TECHNICAL INSTRUCTION

TI 026
Issue 1
February 2006
Page 1 of 3

NETWORK RAIL - SIGNAL ENGINEERING

TPWS Loop Positioning – Minimum Separation

Replace the existing figure A.1 with the following figure:

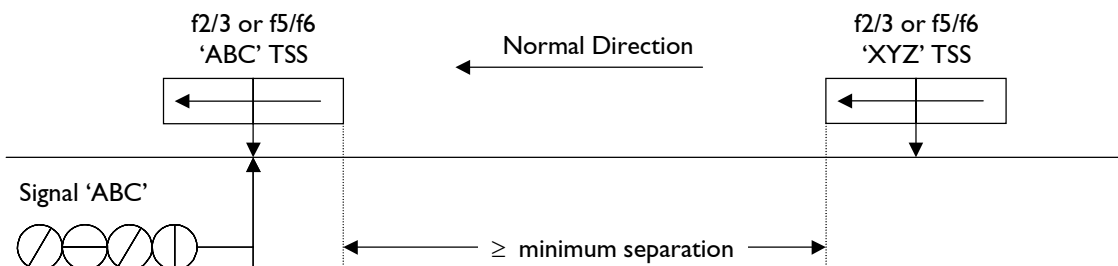
Note: in above diagram f2/3 TSS must not be paired with f1 and f2 OSS and f5/f6 TSS must not be paired with f4 and f5 OSS. The alternative combinations are allowed without minimum separation.
